ATTACHMENT XIII

Approved Traffic Methodology

January 19, 2023

Re: Hollywood Private School - Methodology Requirements

Existing Site Plan
NOT TO SCALE

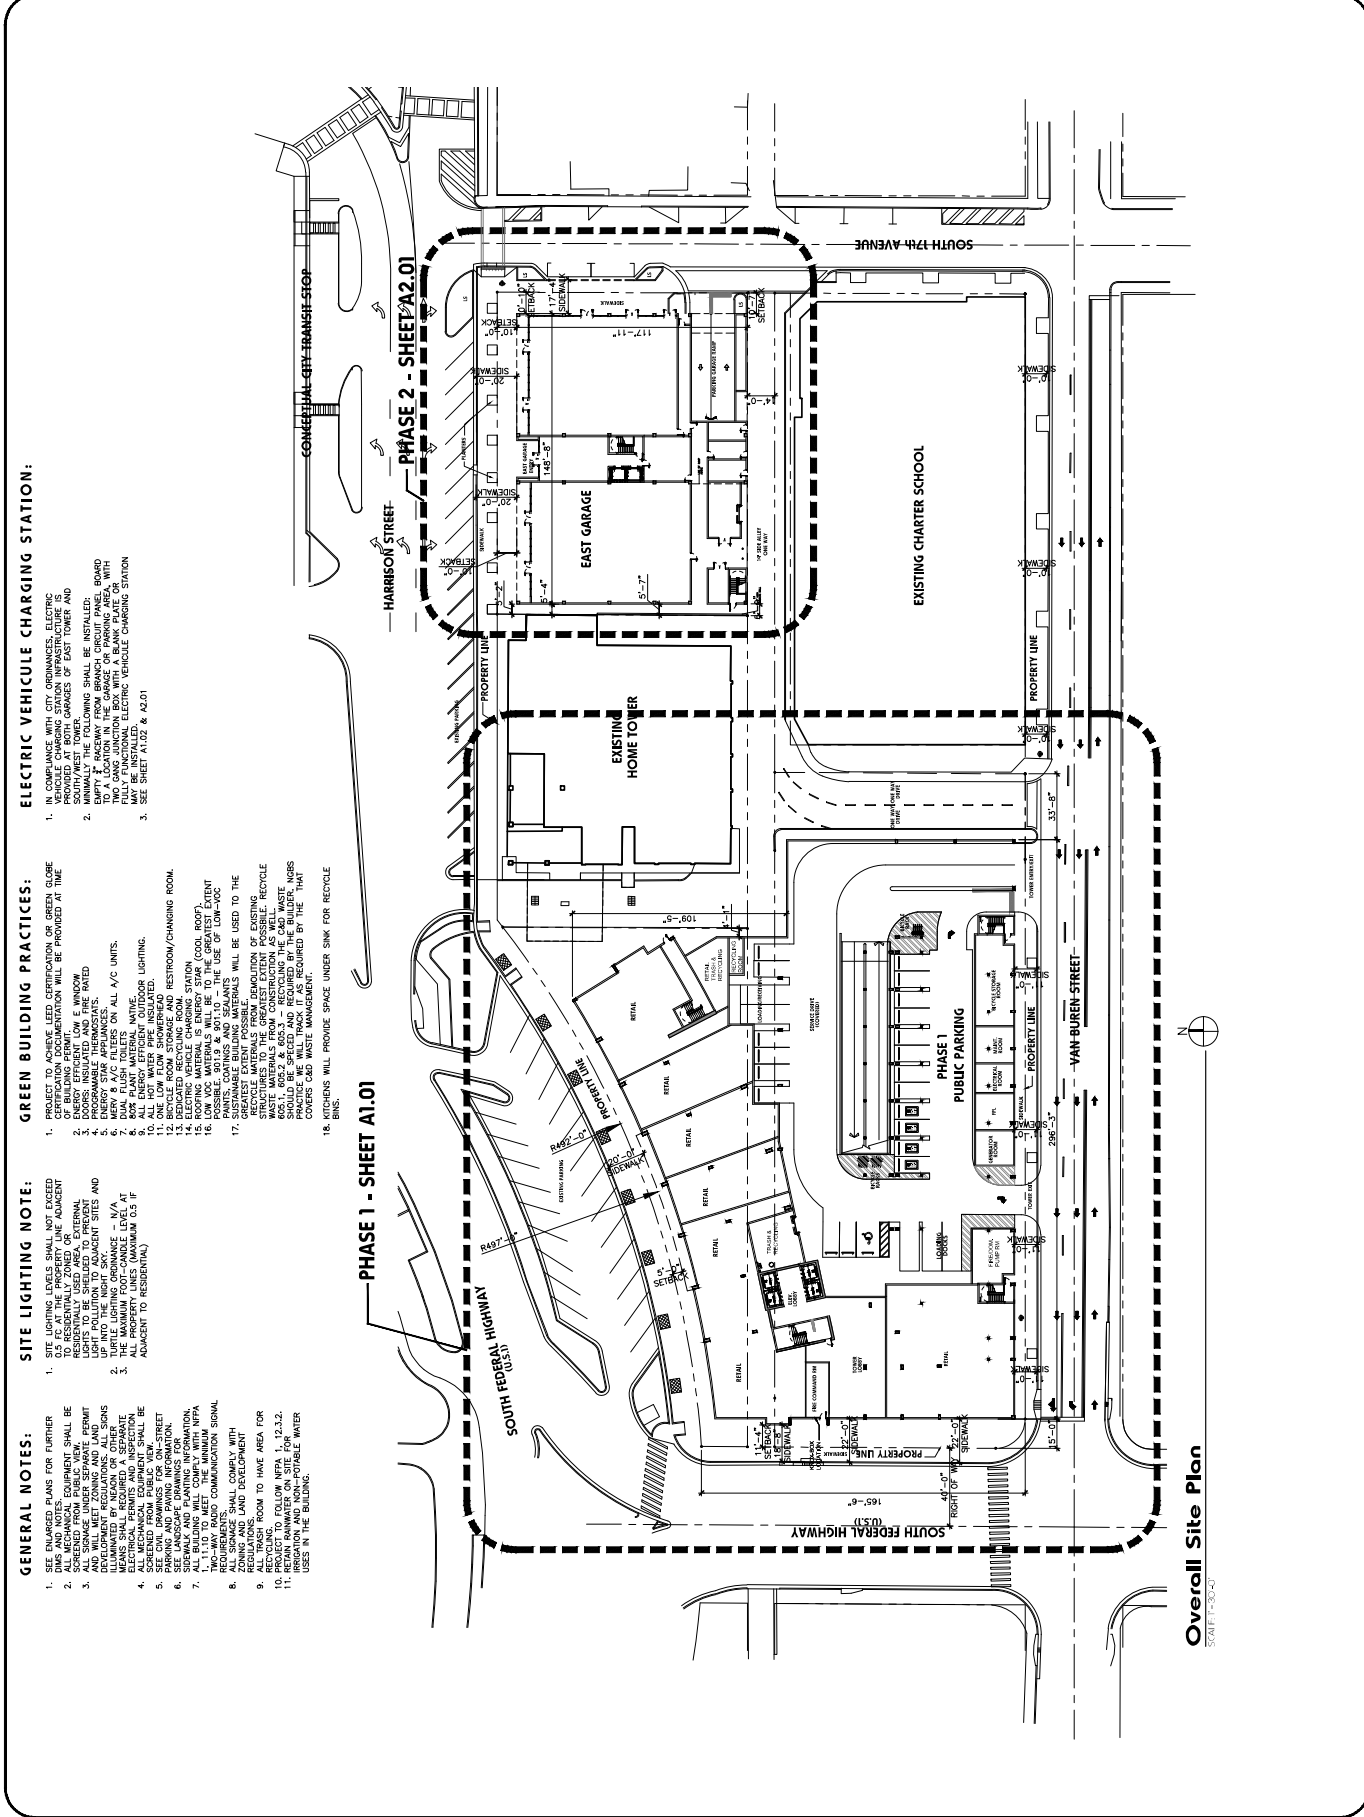
The Hollywood Private School project is proposed to be located at 1720 Harrison Street in an existing building. In reviewing the site plan provided and the site plan for the project site (under construction) to the immediate west, the access to the building for a school use will be problematic. The two (2) site plans are included with this letter.

The two (2) drop-off and pick-up lanes that enter from Harrison Street, have the child exiting on the wrong side of the building and will have to cross in front of vehicles to access the building. Children are required to be dropped off at the building sidewalk, from the passenger side, to avoid conflicts with vehicles for their safety. Crossing in front of the vehicles is dangerous and will not be permitted.

The trip generation for 650 students during the AM Peak Hour of Adjacent Street Traffic is 324 inbound vehicles. The distance from Harrison Street to the crosswalk is 70', which is less than three (3) vehicles. The queue at this location will extend out into the signalized intersection of South Young Circle and Harrison Street.
